Access Compliance Report

Public Rights-of-Way

(Curb Ramps)

Intersection ID: 17925	Main Street: CROSS_WINDS_RD	Cross Street: IDLEWILD_RD	Location: NW
ADA ID: 0A530A695FAA	Ramp Type: BlendTrans2	Initial Pass/Fail: Pass	Overall Compliance: No
Severity Score: 0			
Codes/Mitigation Info/Possible Solution		Field Measurements/Component Compliance

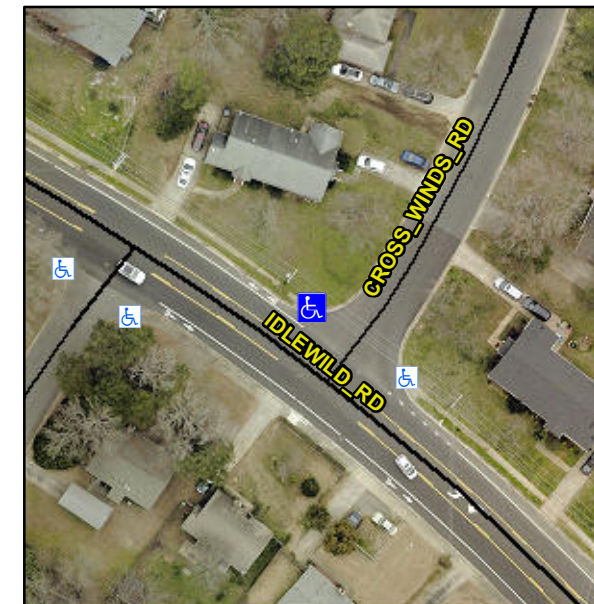
Remove & Replace Curb Slope and Extend Ramp. Remove & Replace Gutter.

Not Found, R304.5.3

N/A	Ramp inside XWalk1?	N/A	N/A	Ramp inside XWalk2?	N/A
	Road Slope (%)	0.9		Clear Space?	Yes
	Road X Slope (%)	0.3	N/A	Clear Space to XWalk (in)	N/A
Yes	Any Obstructions?	No	Yes	Storm Grate/Utility Hazard?	No
	Obstruction Type			Storm Grate/Utility Type	
		N/A			N/A
			Yes	Surface Condition? (G/P)	Good
			No	Curb Slope (%)	14.7
